RHODE ISLAND CONTRACT NO. 2006-CH-072

**Improvements To Interstate Route 195 Interim Shoring South Water Street On Ramp Bridge No. 524**

ADDENDUM NO. 3

DESIGNED BY:  
CHECKED:  
DATE:  
SHEET: 005A  
OF: 018

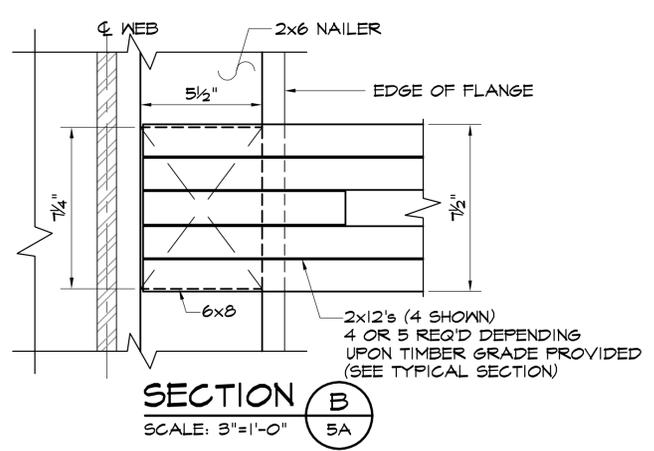
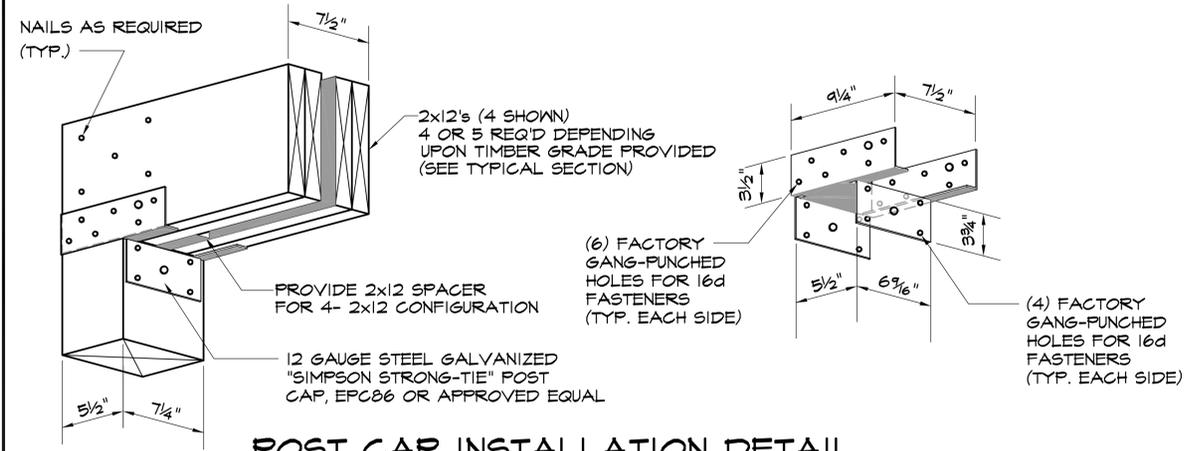
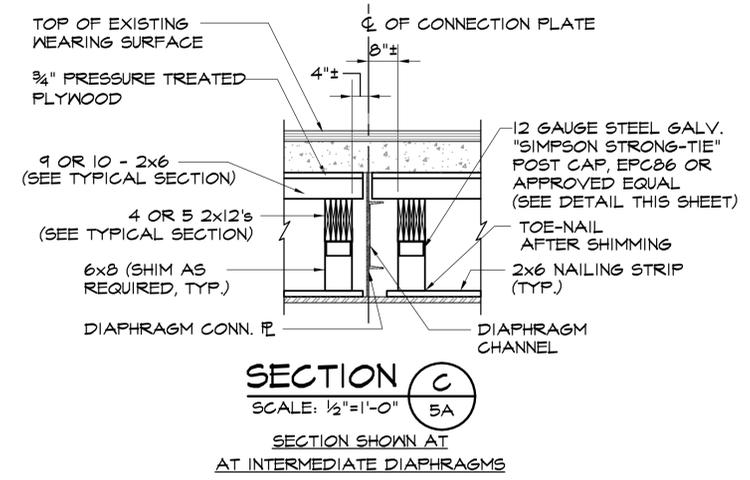
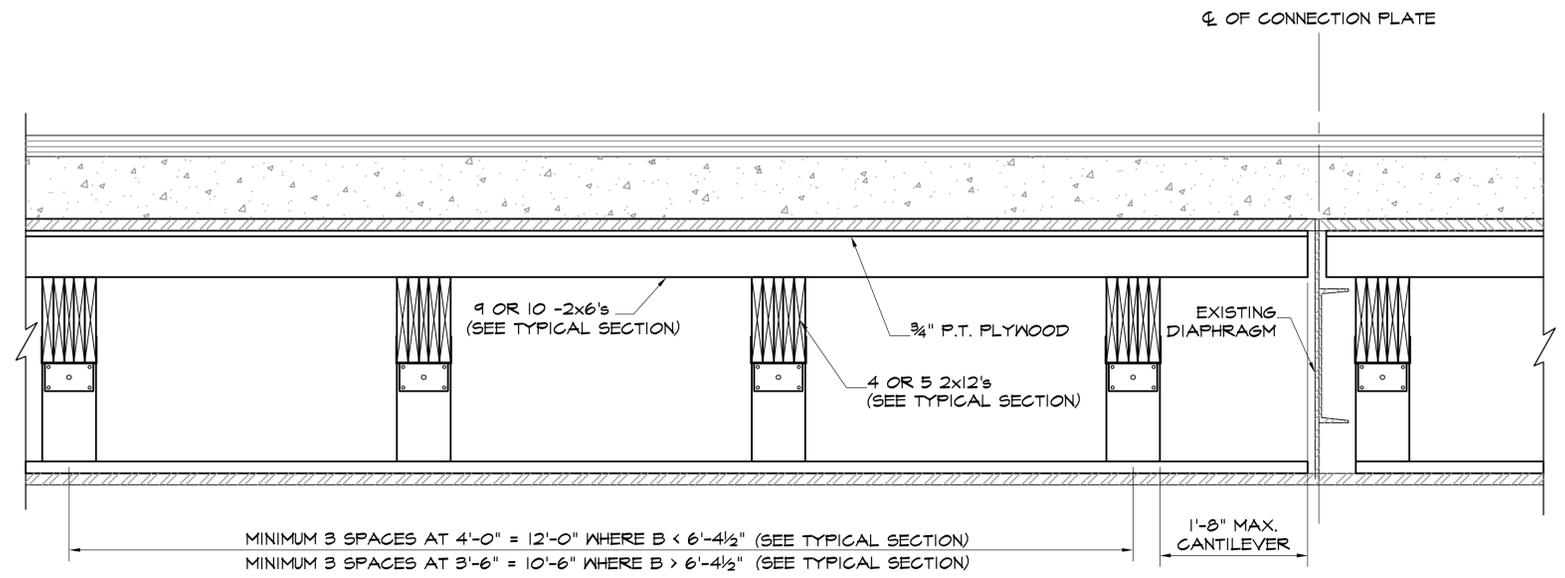
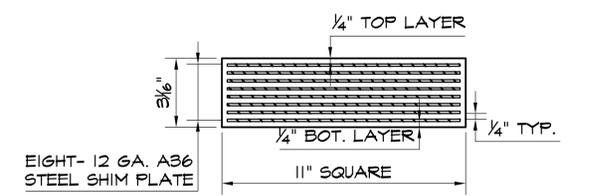
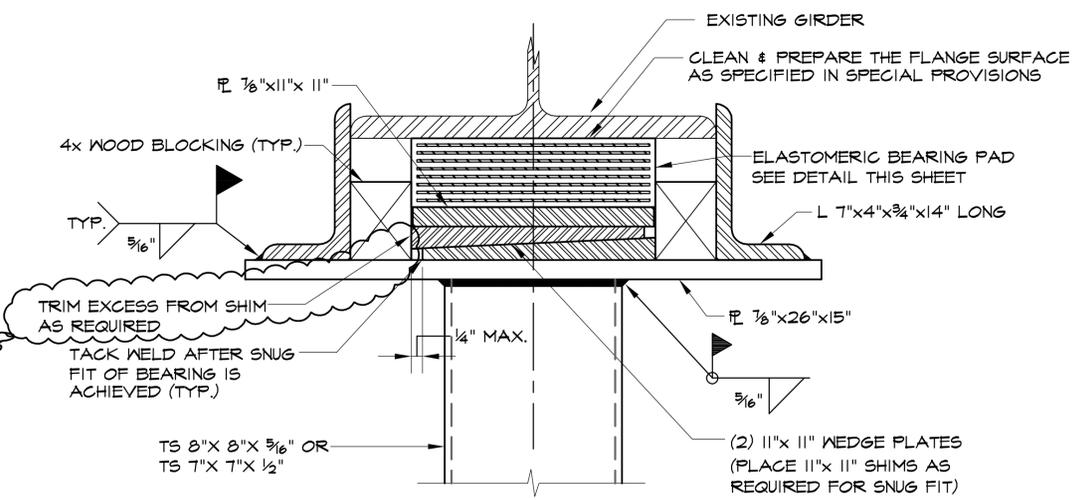
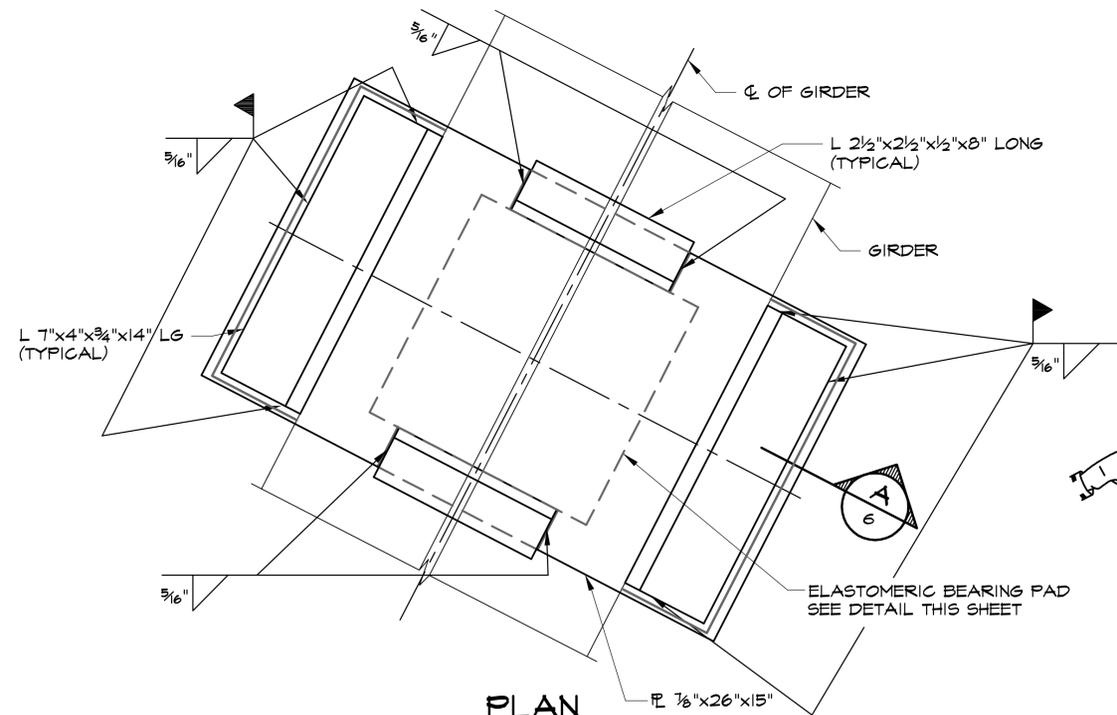
Insert new plan sheet No. 5A Underdeck Shoring Details attached to this Addendum.

**IMPROVEMENTS TO INTERSTATE ROUTE 195**  
 INTERIM SHORING  
 SOUTH WATER STREET  
 PROVIDENCE RHODE ISLAND  
**SHORING TYPE A & TYPE C SCHEDULES**  
 BEARING DETAILS  
 6

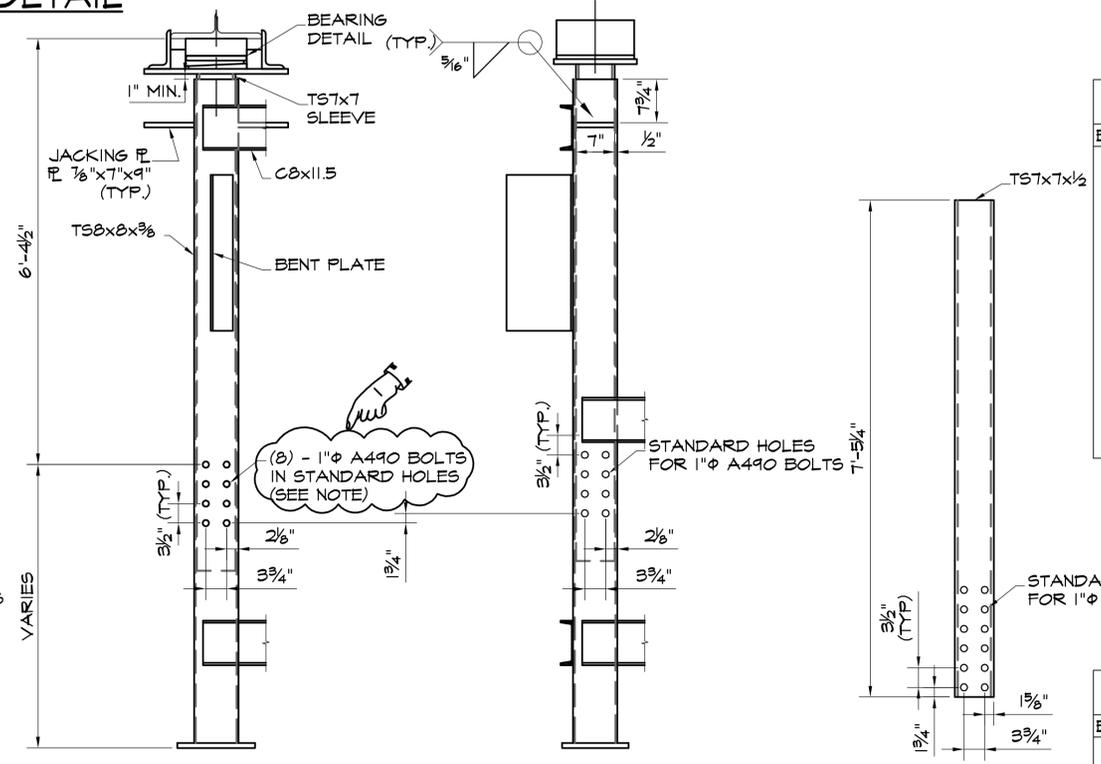
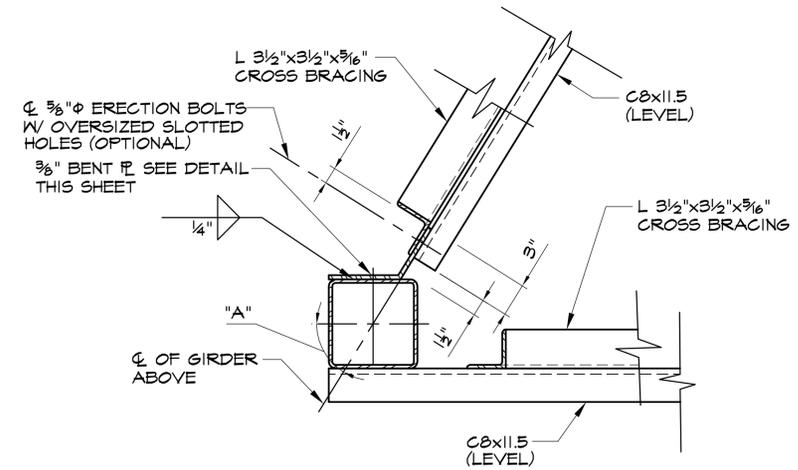
Delete Shoring Type A & Type C Schedules, Bearing Details in its entirety and insert revised Shoring Type A & Type C Schedules, Bearing Details attached to this Addendum. A note to trim excess from shim plates has been added. A note regarding snug-tight fit requirements for the Type C shoring details and references to the note have been added.

**HIGHWAY LEGEND AND GENERAL NOTES**

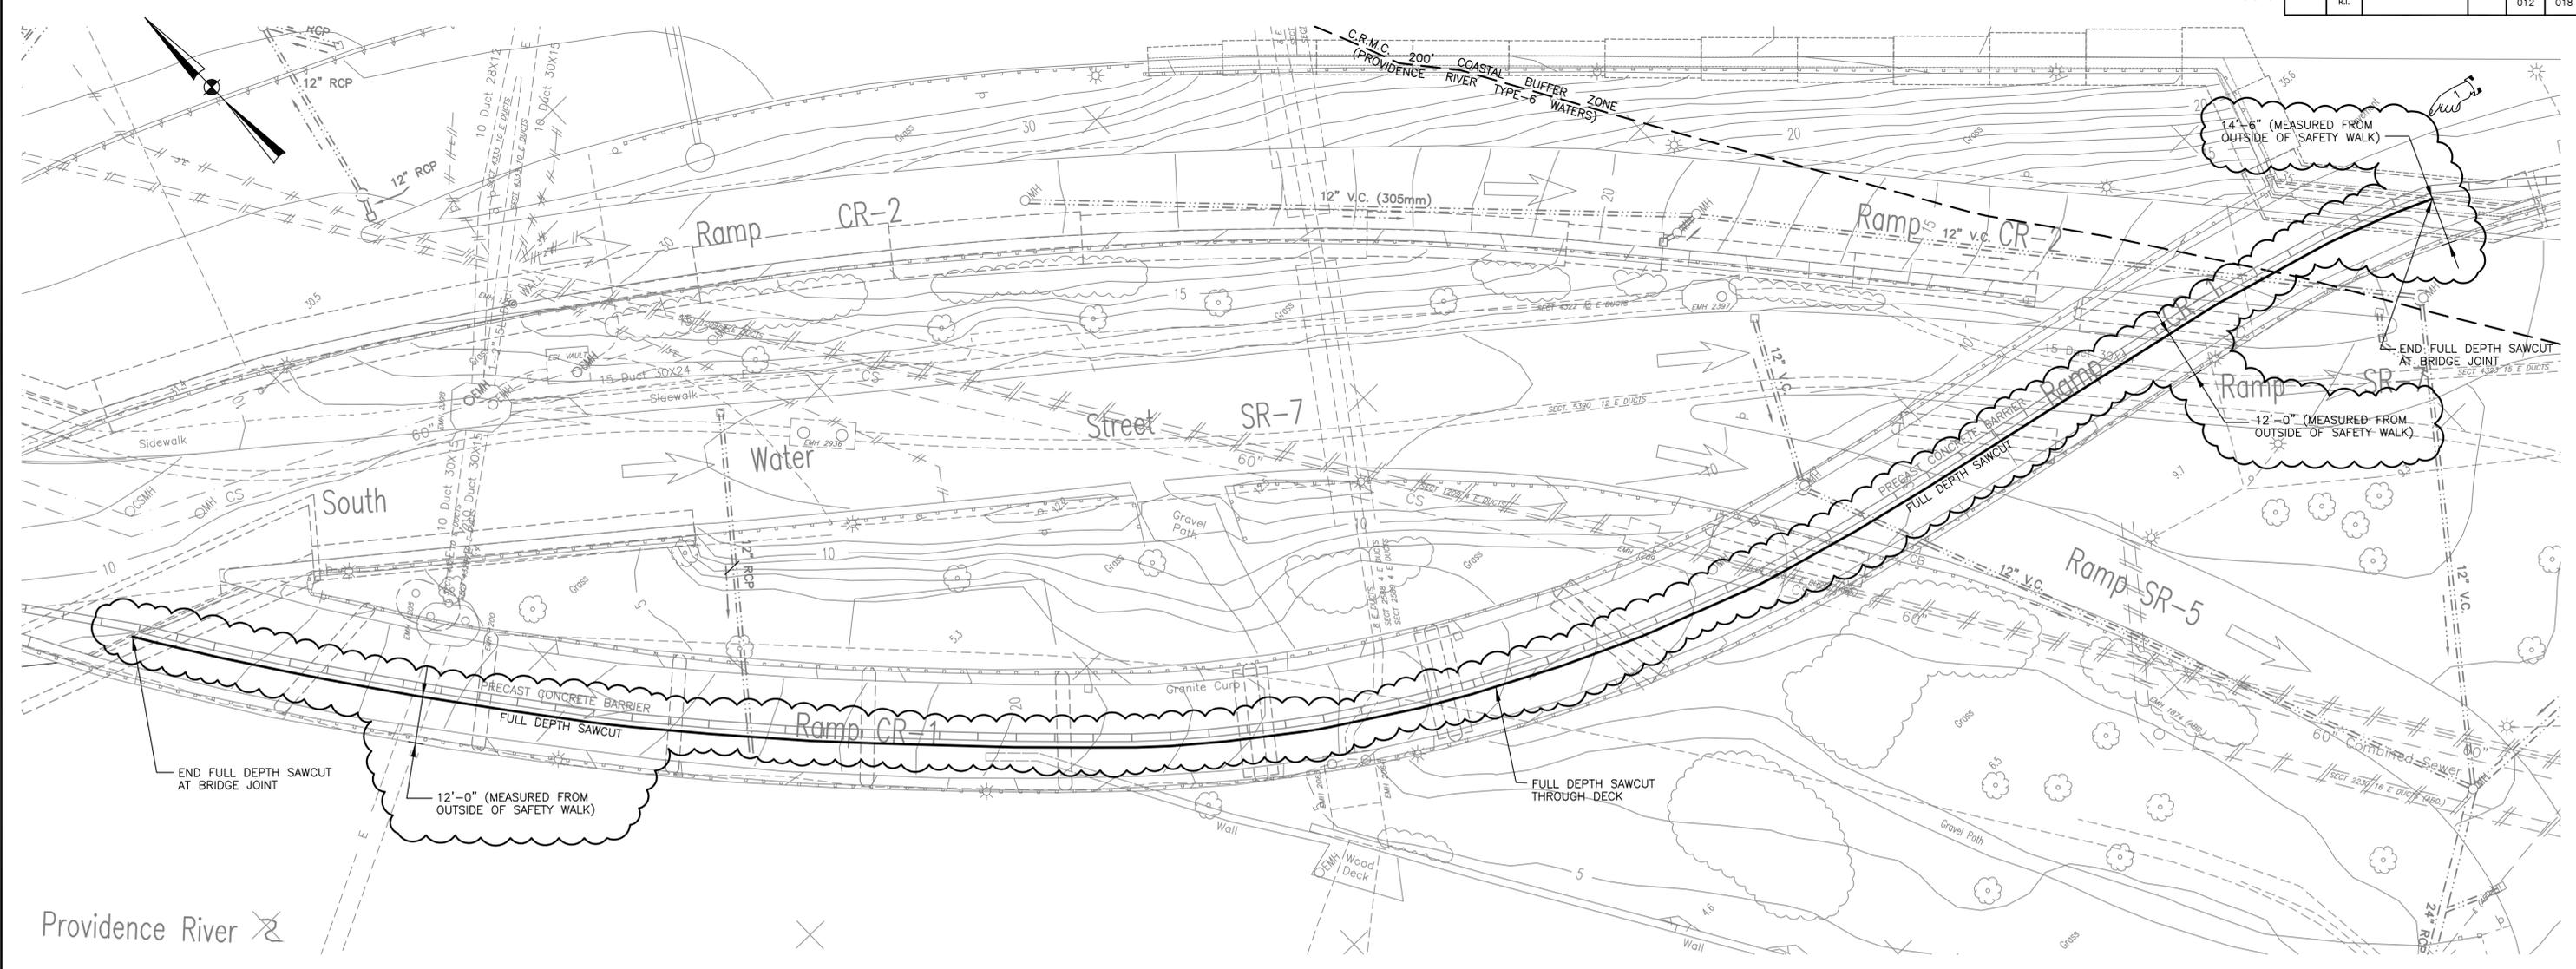
Delete Highway Legend and General Notes in its entirety and insert revised Highway Legend and General Notes attached to this Addendum. RI Standards 26.1.0 and 40.5.0 have been added to the Symbols, Signs W3-4 and W20-7a have been added to the Sign Legend and ETP, FP, GCD, GRD, 34.2.0 and 40.2.0 have been added to the Legend, and RRR and MGR have been deleted from the Legend.

GENERAL PLAN NO. 1 12

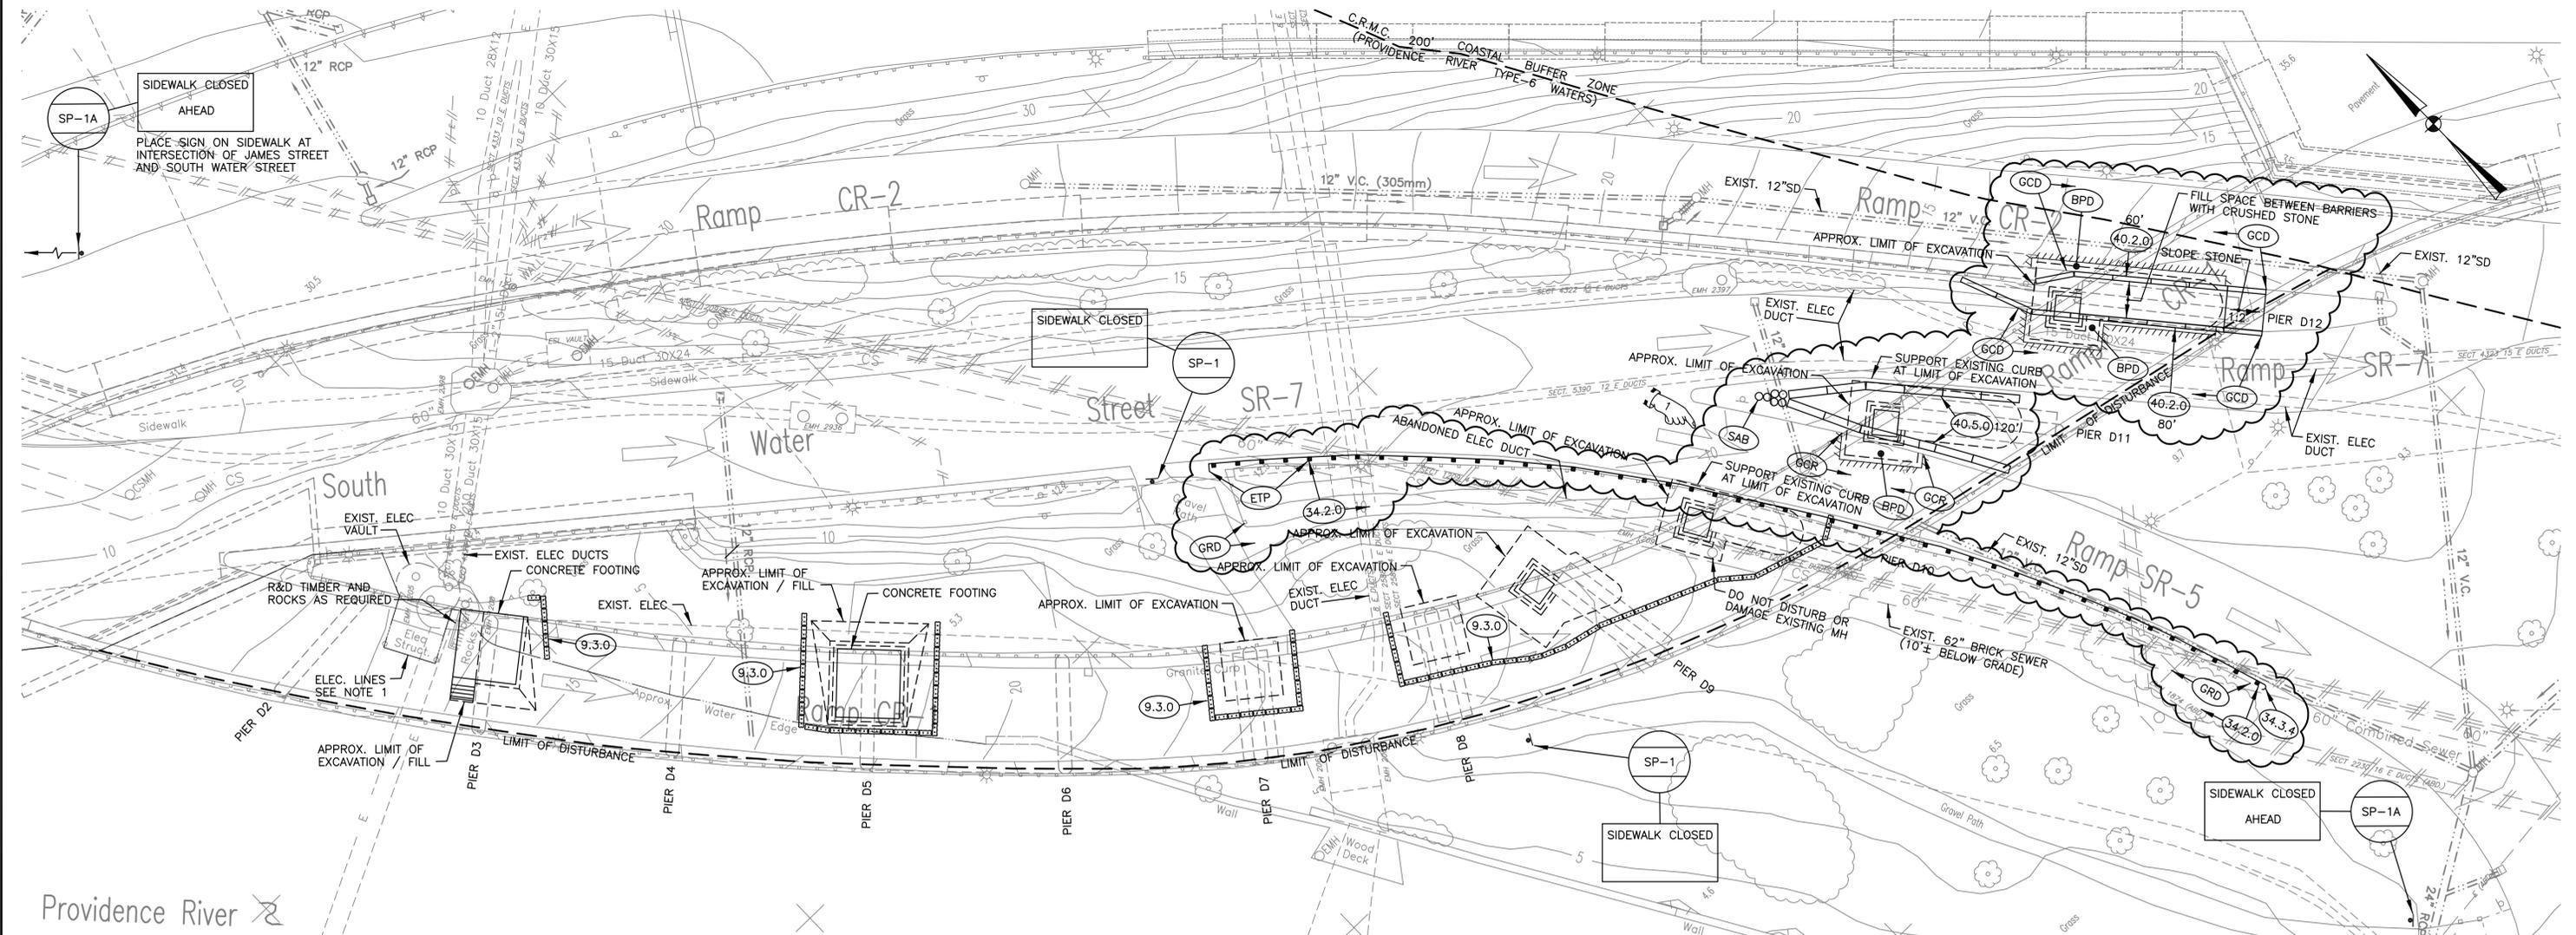
Delete General Plan No. 1 in its entirety and insert revised General Plan No. 1 attached to this Addendum. The distance to the full depth saw cut in the deck has been revised.

IMPROVEMENTS TO INTERSTATE ROUTE 195 INTERIM SHORING SOUTH WATER STREET ON RAMP		PROVIDENCE	RHODE ISLAND
GENERAL PLAN NO. 2		13

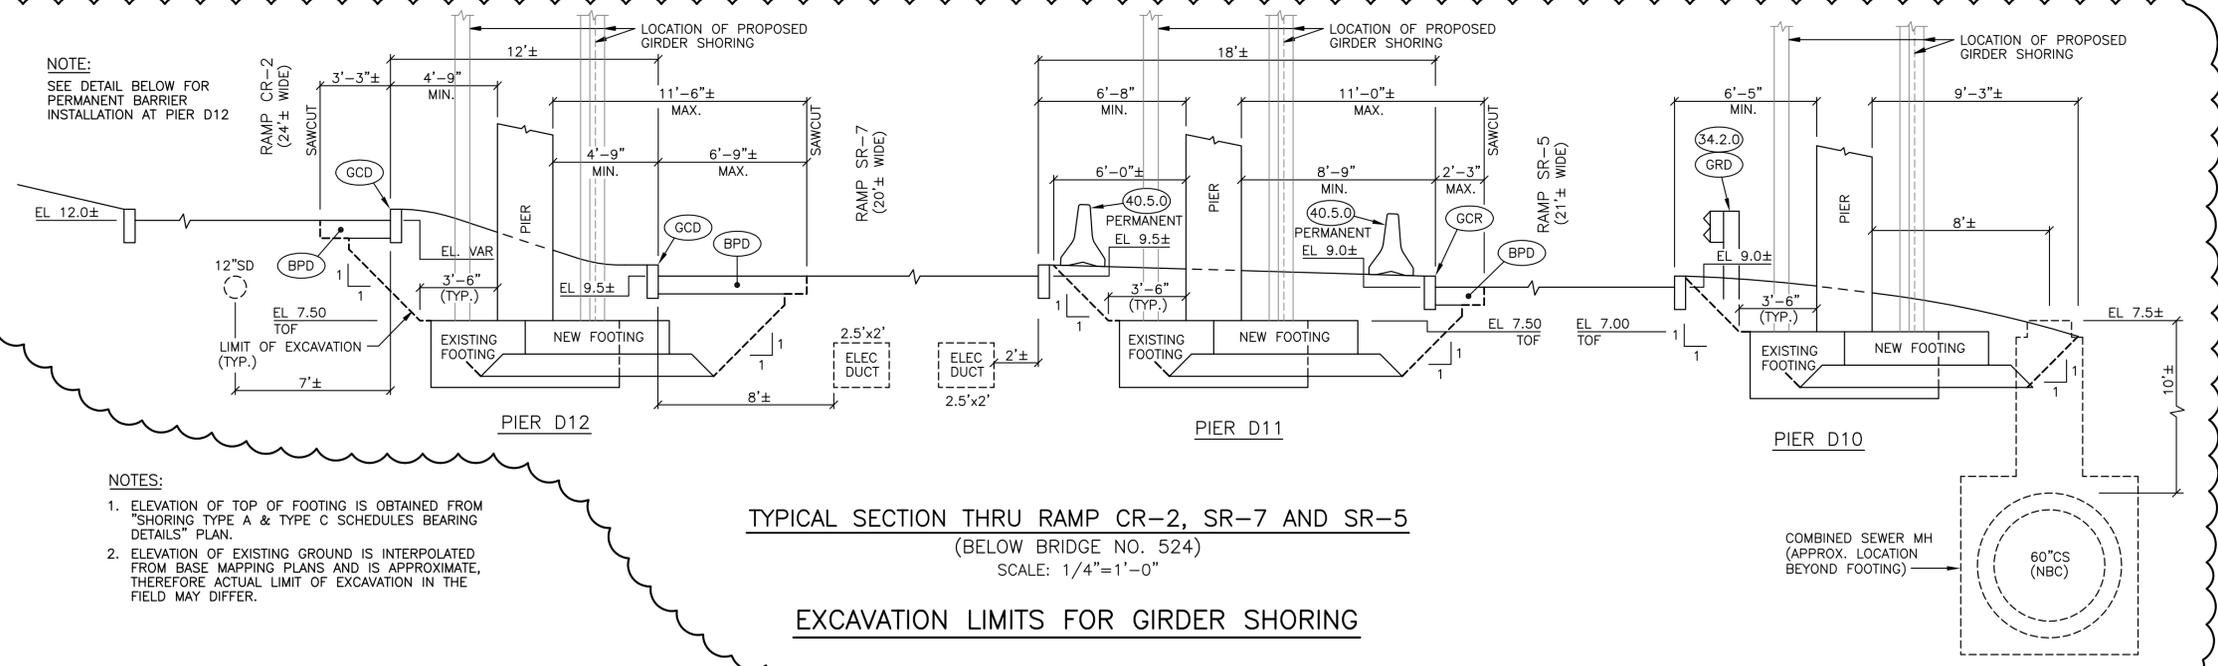
Delete General Plan No. 2 in its entirety and insert revised General Plan No. 2 attached to this Addendum. A new guardrail Standard 34.2.0 with an Extrudal Terminal Approach Section (ET-PLUS) and a Terminal End Section Standard 34.3.4 has been added to replace a deteriorated existing guardrail along the westerly side of existing Ramp SR-5. In addition, a single face precast concrete barrier has been added adjacent to existing Pier D12 between Ramps CR-2 and SR-7.
